PUBLIC INTEREST REVIEW FOR GROUND WATER APPLICATIONS

TO: Water Rights Section Date 27 August 2007
 FROM: Ground Water/Hydrology Section Gerald H. Grondin
Reviewer's Name
 SUBJECT: Application G- 16819 Supersedes review of none
Date of Review(s)

A. GENERAL INFORMATION: Applicant's Name: William & Jana Jones County: Harney

Table showing water-level data for State Well HARN 547, State Observation Well # 169

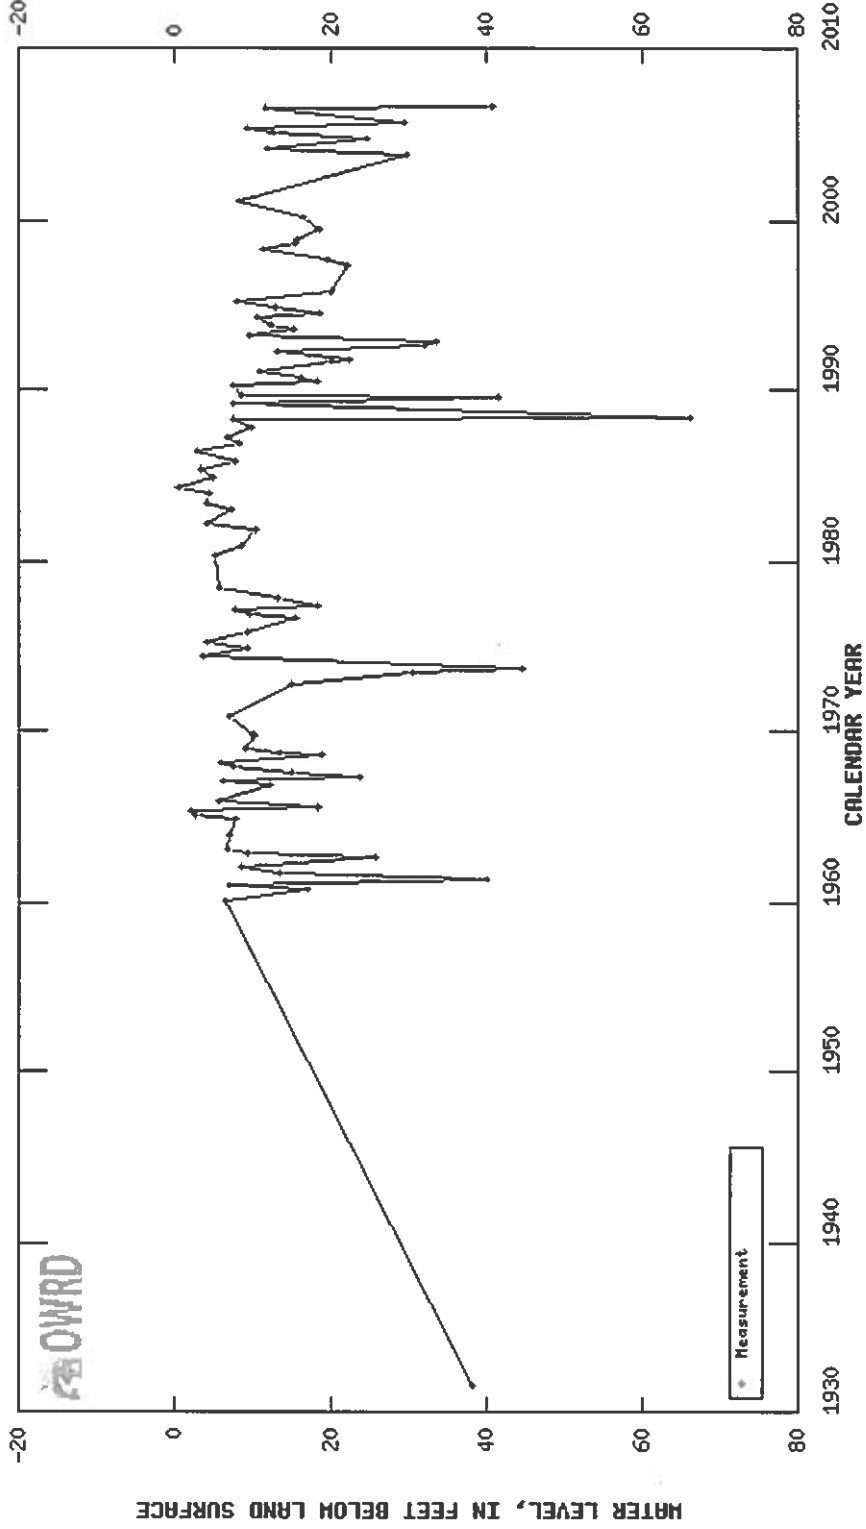
The closest wells with ground water level trend data are wells HARN 547 in T23S/R32E-sec 07 (about 9.3 miles to the west) and HARN 741 in T23S/R34E-sec 31 (about 9.5 miles to the southeast). Both are completed in sediments, and both are in the same sub-basin as the applicant's well. The ground water level data for HARN 547 is from 1960 to 2006 and for HARN 741 is from 1974 to 2006. The ground water level trend at each site show seasonal and climatic influences. A possible net decline of less than 5 feet may have occurred at both sites. Interestingly, no recovery of the annual trend is apparent from 1996 to 1999, a generally wetter than average period in Oregon. Seasonal ground water level fluctuations range from 10 to 40 feet. This could adversely impact the use of shallow wells, but likely not adversely impact the use of deeper wells.

Well 1 (G-16819) to Ninemile Slough & Tributaries

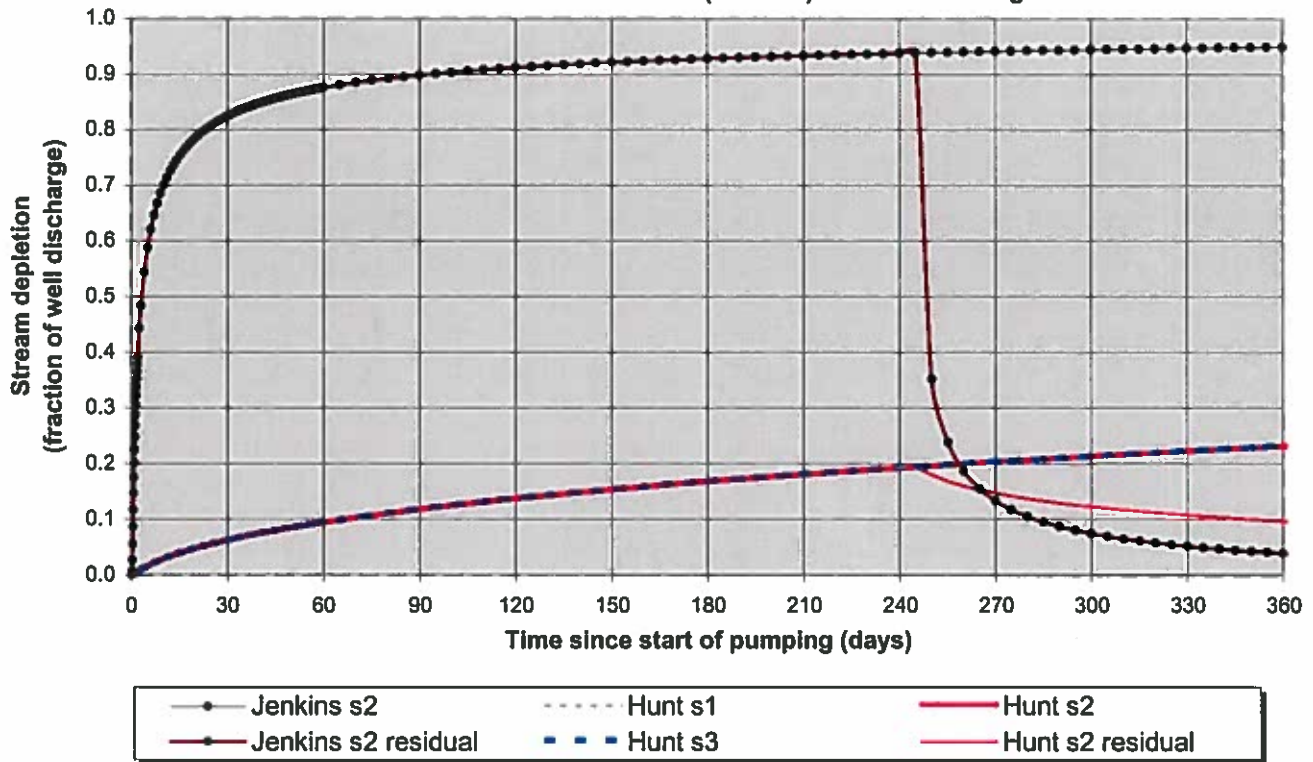
The distance from owner proposed well 1 to Ninemile Slough and tributaries is less than 1 mile (4,700 feet).

Potential for substantial interference must be assumed given the proposed pumping rate exceeds 1 percent of the natural flow (80 percent exceedance).

Hunt (1999) was used to calculate the interference at Ninemile Slough and tributaries given the well will likely not penetrate the basin fill sediments. The values used for the calculations are conservative and appropriate until better values become available. The calculations used a transmissivity of 7,500 ft²/day which is consistent for Eastern Oregon basin fill transmissivities noted by Gonthier (1985) and transmissivity values derived from specific capacity data from wells in T23S/R32.57E-sec 10, 13, 14, 15, 22, and 24 (HARN 564, HARN 641, HARN 642, HARN 645, HARN 648, HARN 649, HARN 650, HARN 651, HARN 657, HARN 1870, HARN 50054, HARN 50491, HARN 50514, and HARN 51204). Additionally, the calculation used an assumed intermediate storage coefficient (0.001). The hydraulic conductivity assigned to the bed of the tributary is 0.20 feet/day.

Well 1 (G-16819) to Malheur Slough & Tributaries

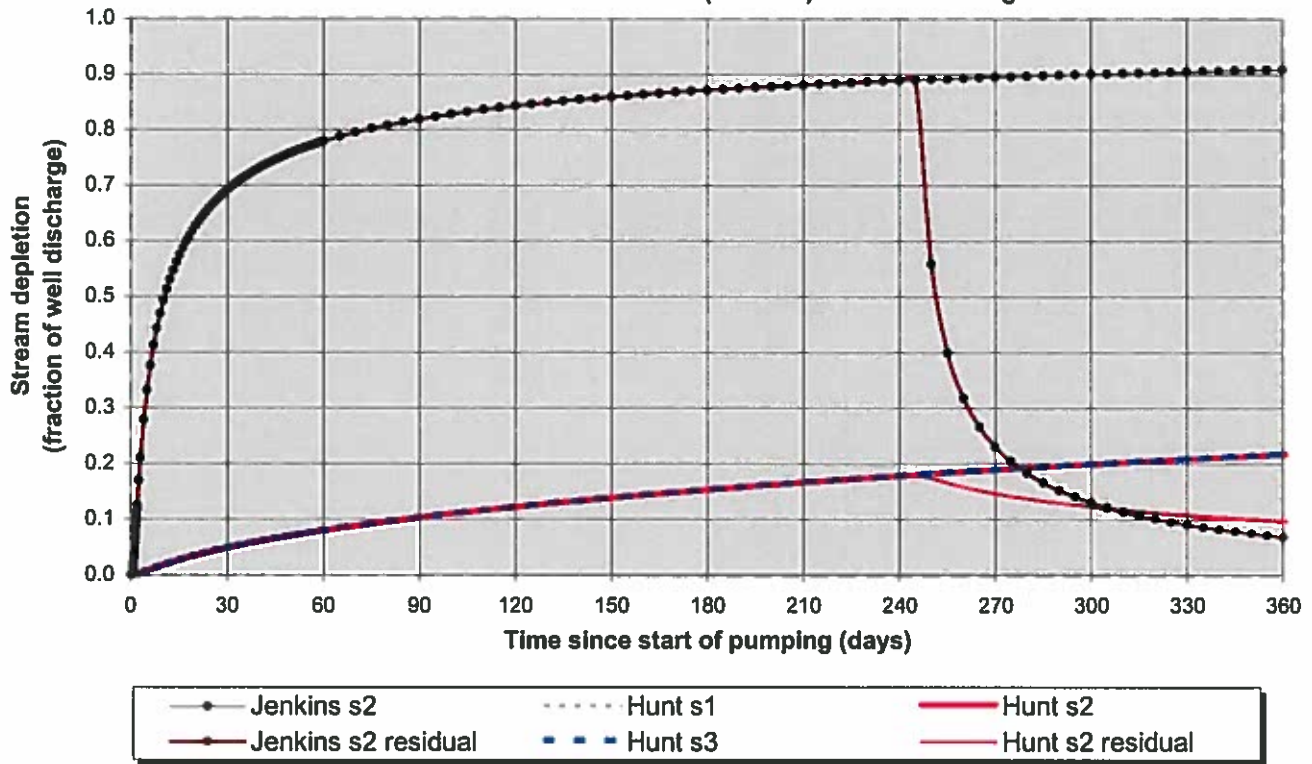
The well site is more than 1 mile from Malheur Slough (8,400 feet).

Hunt (1999) was used to calculate the interference at Malheur Slough and tributaries given the well will likely not penetrate the basin fill sediments. The values used for the calculations are conservative and appropriate until better values become available. The calculations used a transmissivity of 7,500 ft²/day which is consistent for Eastern Oregon basin fill transmissivities noted by Gonthier (1985) and transmissivity values derived from specific capacity data from wells in T23S/R32.57E-sec 10, 13, 14, 15, 22, and 24 (HARN 564, HARN 641, HARN 642, HARN 645, HARN 648, HARN 649, HARN 650, HARN 651, HARN 657, HARN 1870, HARN 50054, HARN 50491, HARN 50514, and HARN 51204). Additionally, the calculation used an assumed intermediate storage coefficient (0.001). The hydraulic conductivity assigned to the bed of the tributary is 0.20 feet/day.
